**Subject: *Focused Feasibility Study for the Second Interim Remedy*
 North Hollywood Operable Unit, San Fernando Valley Superfund Site**

This letter provides comments on the July 2009 draft Focused Feasibility Study (FFS) for the North Hollywood Operable Unit (NHOU), San Fernando Valley (SFV) Area 1 Superfund Site, Los Angeles County, California, prepared by the U.S. Environmental Protection Agency (EPA; USEPA, 2009). The NHOU is located at 11600 Sherman Way, North Hollywood, California (Site), which is known as the "former Bendix facility." The FFS presents an evaluation of NHOU conditions since implementation of the First Interim Remedy in 1989, and proposes cleanup goals and remedial alternatives for the implementation of a Second Interim Remedy.

Attachment 6

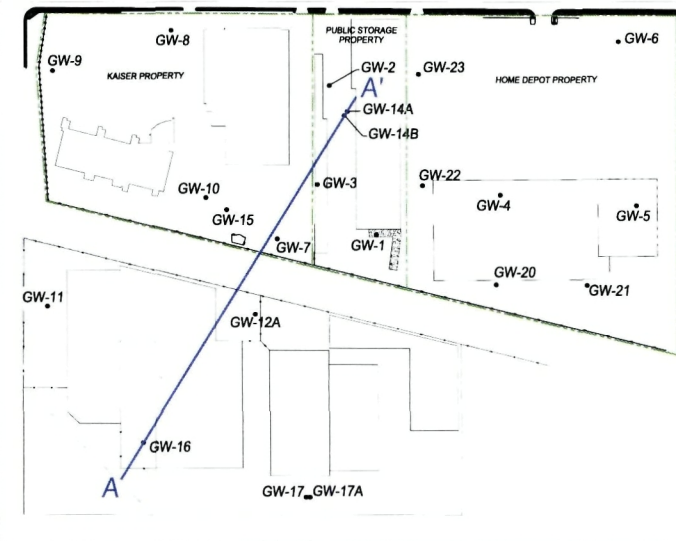
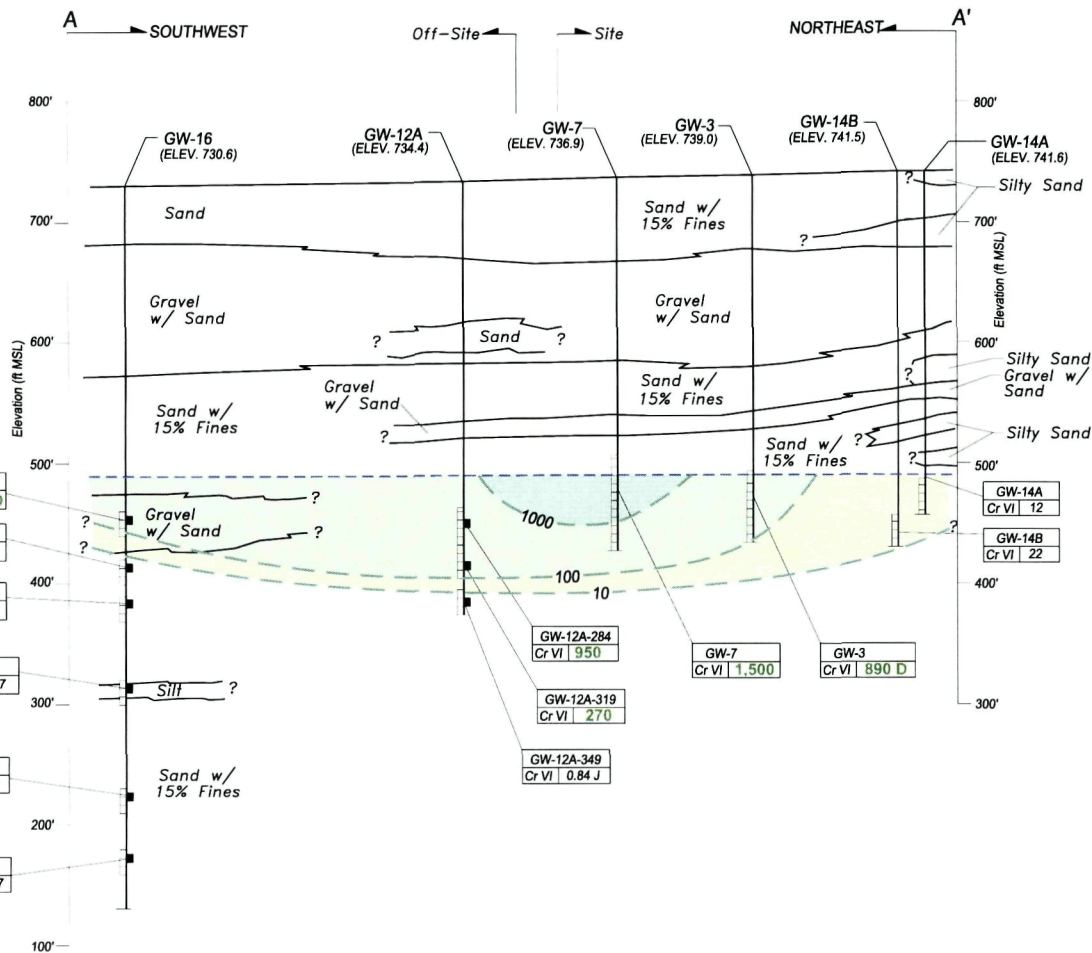
For example, the attached figure illustrates 1,4-dioxane concentrations in groundwater around the former Bendix facility (**Attachment 6**). The figure shows the most recent groundwater sampling results, including results from newly-installed well NH-C07 (U1-1). Upgradient 1,4-dioxane concentrations range from 3.5 µg/L in GW-9 to 7.4 µg/L in GW-6. With the exception of one location (11 µg/L of 1,4-dioxane at GW-12A), downgradient concentrations are similar to upgradient concentrations. The groundwater analytical results from soon-to-be-installed well T2-1 will provide additional information on the distribution of 1,4-dioxane in the area. The results may indicate that 1,4-dioxane at concentrations of 3 µg/L to 10 µg/L may be present intermittently throughout much of the VOC plume. This is very different than the 1,4-dioxane plume presented in Figure 2-8 of the FFS. If 1,4-dioxane is present intermittently throughout much of the VOC plume at these levels, wellhead treatment for 1,4-dioxane at NHE-2 may not be an appropriate remedy. Depending on the spatial variation, frequency, and concentration ranges of the 1,4-dioxane in groundwater, the remedy could range from no 1,4-dioxane treatment to the addition of 1,4-dioxane treatment at the NHOU Central Treatment Facility.
